Doc Ref: WG345-06F02(rev1)- WS Letter

RE: UNITING CHARLESTOWN, 27 TIRAL STREET, CHARLESTOWN
PEDESTRIAN WIND ENVIRONMENT STATEMENT LETTER

Figure 1: Recommended Treatments for Building B and the Bridge Link

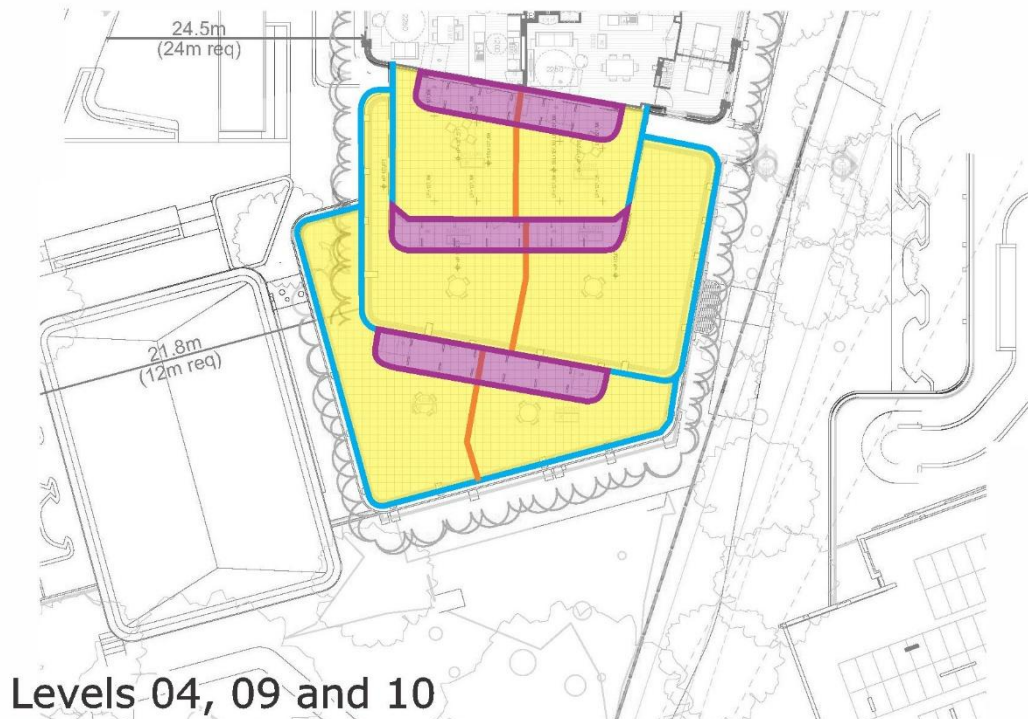
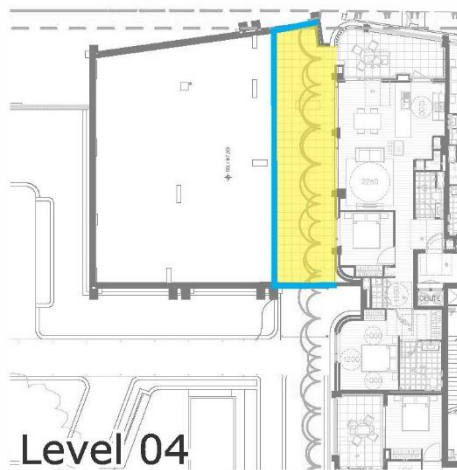
The expansion of the north-eastern corner balcony on Level 01 results in greater exposure to winds from the west-northwest and northeast. Hence it is recommended that at least 1.8m high impermeable intertenancy screening be included to help stagnate winds within this area while also shielding the adjacent balcony.

The bridge link between Buildings A and B is also exposed to all three prevailing winds funnelling between the two buildings as indicated in the Pedestrian Wind Statement. However, conditions are expected to be adequate with the retention of the operable glazed louvres in the latest design. These louvres allow for enclosure of the bridge link during high wind conditions, but it should be noted that manual operation is at the discretion of maintenance staff during typical hours.

With the expansion of the southern balconies on Level 04 and Level 09, it is recommended that impermeable balustrades be included along the perimeter similar to Level 10 to mitigate adverse wind effects from the prevailing wind directions. The same is recommended for the expanded northwestern balcony on Level 04. Additionally, the proposed awnings above the southern balconies should be made impermeable with the intertenancy screening be increased to at least 1.8m high.

Due to the increased size and therefore exposure of the balcony areas, adverse wind conditions may present within them which require strategic wind mitigation measures. It should be noted that these additional treatments can be determined at a later stage based on the results of wind tunnel testing.
